RESPONSE TO SUBMISSIONS REPORT

Abel Tasman Village Seniors Housing

SSD-49937206

Concept & Detailed State Significant Development Application
222 Waldron Road & 138-140 Campbell Hill Road
Chester Hill, NSW

Figure 1: Extract Dwg. A1DA21 – Building A L2-5 plan - Interface with R3 zone

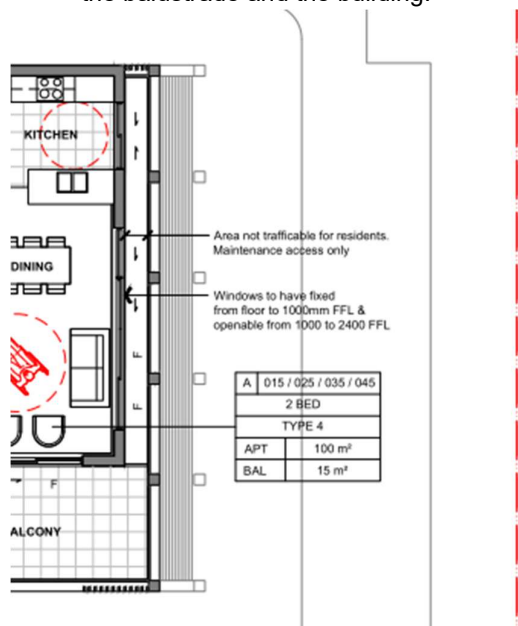
(1) Bulk and Scale – Buildings A and E	- Reduce the bulk and scale of Buildings A and E at the interface with the R3 zone; - Overlooking from Building A to north

- Full height, north-facing, glazed doors replaced with fixed window up to 1m, stopping access to the balcony in front. Access from the main balcony is restricted physically by a fence between the balustrade and the building.

- Balconies - Units 12-14, 22-24, 32-34, 42-44 - Fixed louvres on the northern balustrades replaced with adjustable louvres.

Figure 7: RtS revision - Extract Dwg. A3DA33 - Building C South elevation

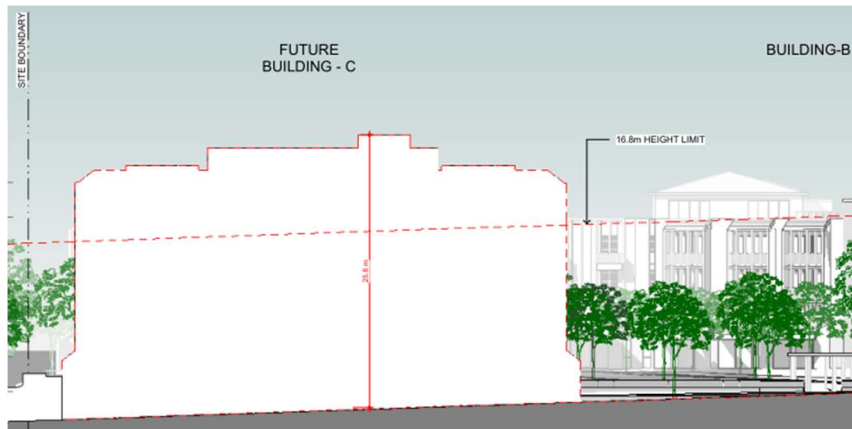
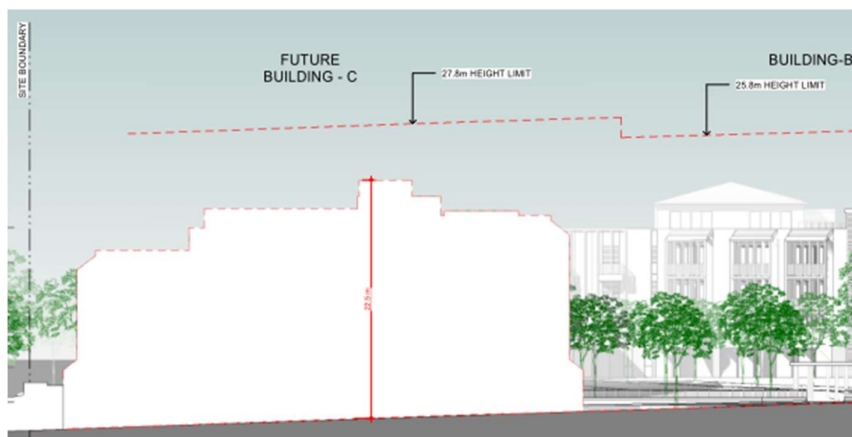
(2) Bulk and Scale – Building C	▪ Design amendments required to reduce the height of Building C. ▪ Reduce the bulk and scale of Building C to improve the streetscape, reduce overshadowing to the south and provide a better transition in form with the public reserve.	To reduce the perceived massing of the future building, and reduce overshadowing, Building C has been revised to remove one (1) storey and to provide a recessed upper floor setback from the reserve to the new uppermost level.

Refer to the extracts below from the SSDA lodged and RtS revision of the south elevation of Building C for comparison.

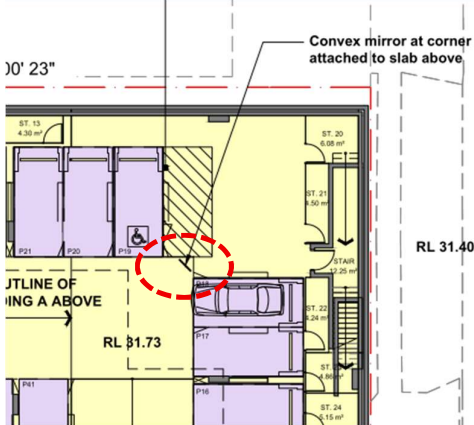
▪ <i>Hydracor stormwater management site plan sheet 2 of 6 shows a 450 RCP to connect with existing lintel but ADP stormwater plan – ground floor shows pipe connected to a proposed lintel.</i>	Refer to Appendix D – Stormwater Plans, prepared by ADP.

Figure 9: Project – LMR housing context

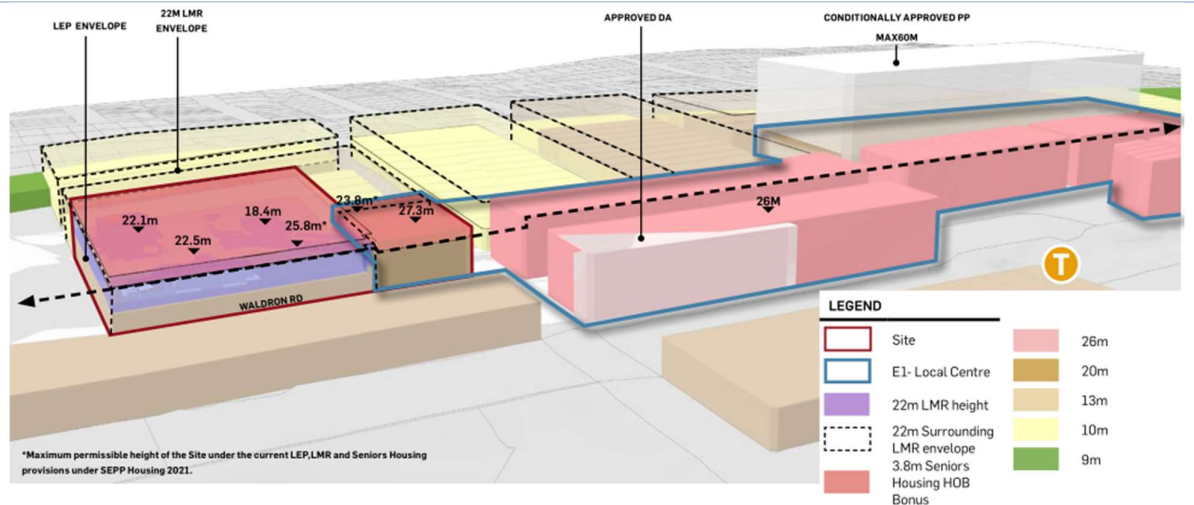
DPHI	Summary of key issues	Response
(1) Bulk and Scale – Buildings A and E Interface with R3 zone to north	- Reduce the bulk and scale of Buildings A and E at the interface with the R3 zone; - Recommended upper level setbacks.	Building E has been amended to create an upper level setback at its northern interface with the R3 zone and also to include an additional part level, also recessed from the northern boundary. The modification is to partly compensate for the removal of accommodation in Building C in Stage 2 and L4 of Building E. No changes are proposed to the overall form of Building A. The spatial relationship between Building A and the R3 zoned land is considered to be appropriate in light of the influence which Chapter 6 of SEPP(Housing), 'LMR Housing', will have on the built form character of the centre and, in particular, the R3 zoned land to the north of the site. The LMR now makes '<i>residential flat buildings</i>' on the neighbouring land permissible. The maximum building height of the development is also based on the maximum permitted height under the LMR provisions and it is only reasonable that the future character and context is also considered in this light. Following the gazettal of CBLEP23, which created new zoning and higher FSR and height standards for the centre, the LMR housing provisions were published, creating the potential for significant additional development opportunities beyond that anticipated in the LEP. In an overall sense, the proposed concept development will sit comfortably in the LMR housing context, as shown below in the extract from the revised Design Report (App. L).

Building A, as an important corner building at the entry to the centre, is justifiably more prominent. In this case, the applicable planning framework creates the contrary transition in massing since a greater maximum building height is available on the R4 zoned land than the E1 Local Centre land, which is located within the LMR 'town centre' and where the LEP is adopted as the base height standard.

Figure 12: Building A - Ground floor analysis

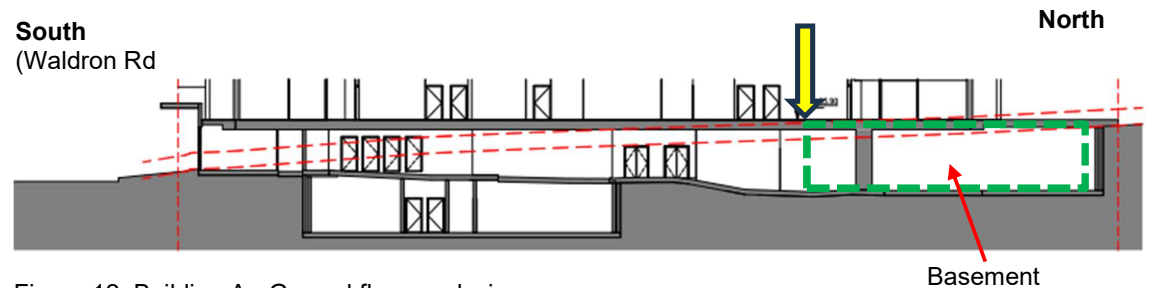
(4) Use of ground floor in Zone E1 (Building A)	- Non-compliance with Clause 6.21 of the CBLEP. - Provide further information demonstrating how the proposal satisfies the intent of clause 6.21 of CBLEP and s.89(2) of SEPP(Housing), specifically, the activation and streetscape outcomes along the Campbell Hill Road frontage.

The critical step to determine compliance with this clause is the correct identification of the ‘*ground level of the building*’, which is not straightforward in the context of this project due to the sloping topography of the site from north to south (and east to west); the floor slab of the retail tenancies fronting Waldron Road being excavated back into the site behind; and, the absence of a definition for the ‘*ground level of a building*’ in SEPP(Housing) or CBLEP.

The identification of the floor levels starts with the “*basement*” since it is defined in the LEP. Figure 12 below shows a section extract of the lower floor levels of Building A. The lower dashed red line is the existing ground level. The upper dashed line is plotted at 1m above the existing ground level to reflect the definition above.

The part of Building A, facing the primary frontage, Waldron Road, includes retail tenancies with an excavated area behind, accommodating parking and building services. The level is “*predominantly below ground level*”, since the level extends further across the site to service Buildings B and E, where it is entirely below ground level. The extent of basement is defined where the floor level of the storey immediately above is less than 1m above existing ground level, as indicated above. The area to the north of that point is “*basement*”. It therefore follows that the remaining floor area at this level is “*ground level*”.
